**OHIO TURNPIKE AND
INFRASTRUCTURE COMMISSION**

ADDENDUM NO. 2
ISSUED JANUARY 16, 2020

PROJECT NO. 39-20-02 (PART A)
MAINLINE PAVEMENT RECONSTRUCTION
MILEPOST 46.50 TO MILEPOST 50.92
FULTON & LUCAS COUNTIES, OHIO
ISSUED DECEMBER 30, 2019

PROJECT NO. 39-20-02 (PART B)
TOLL PLAZA 49 SITE CONSTRUCTION
MILEPOST 48.8 TO MILEPOST 49.1
LUCAS COUNTY, OHIO
ISSUED DECEMBER 30, 2019

DESIGN AGENCY: **JACOBS**
 PROJECT: WESTBOUND TOLL PLAZA CROSS SECTIONS
 STA. 26+00 TO STA. 28+00
 LUCAS COUNTY
 DATE: 12/20/2019
 TP 49
 4 / 7
 40
 59

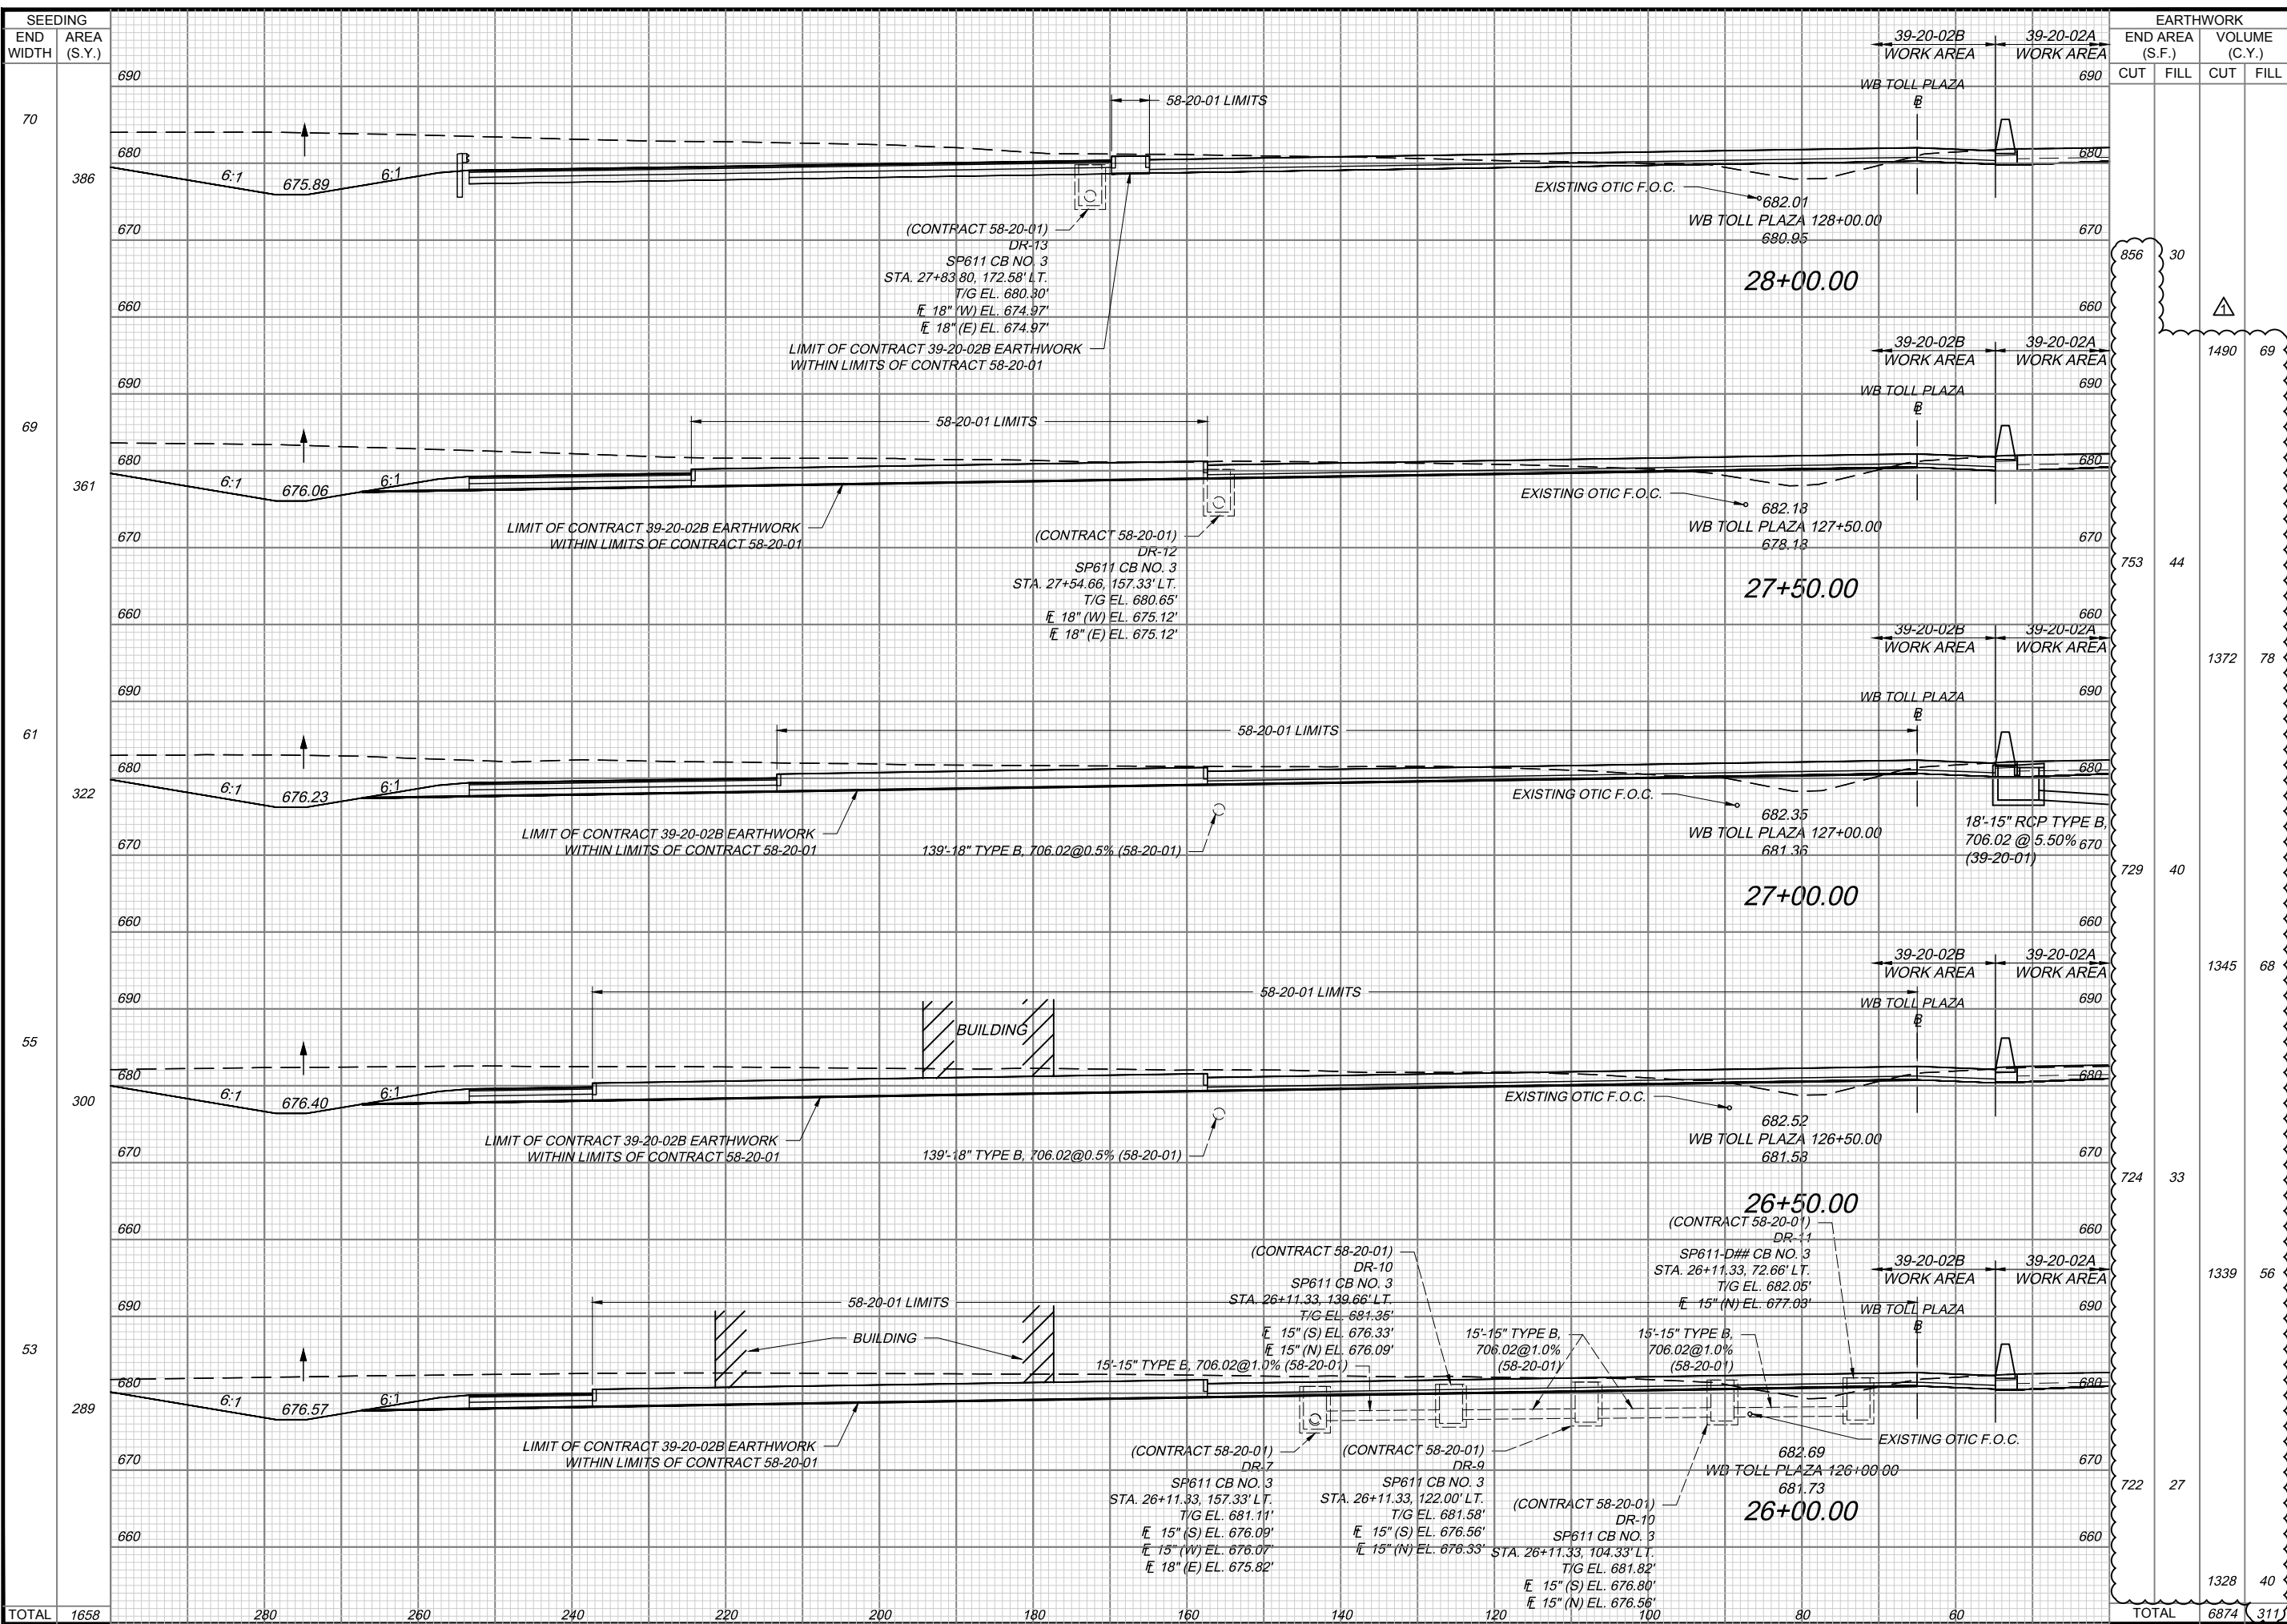
Q#40 Part B Bid Items 271 (Excavation) and 272 (Embankment): the subsummary references quantities on sheet 54, which in turn summarizes cross-sectional volumes from plan sheets 30-54. There are numerous mistakes in the cross-section plan sheets 30-36, most in the omission of volumes between stations from consecutive plan sheets and a one in the calculating of end areas into volumes. Please review these plan sheets and revise excavation and embankment items accordingly.

A#40 This Addendum No. 2 revises the Excavation and Embankment quantities on the Cross-Section Sheet Nos. 30 through 53 of 59 and the General Summary Sheet No. 16 of 59, and revises Reference Nos. 271 and 272 on the Bid Schedule of Items and the Estimated Quantities Worksheet. An Excavation and Embankment Sub Summary Table totaling the quantities by sheet was added to Sub Summary Sheet No. 18 of 59.
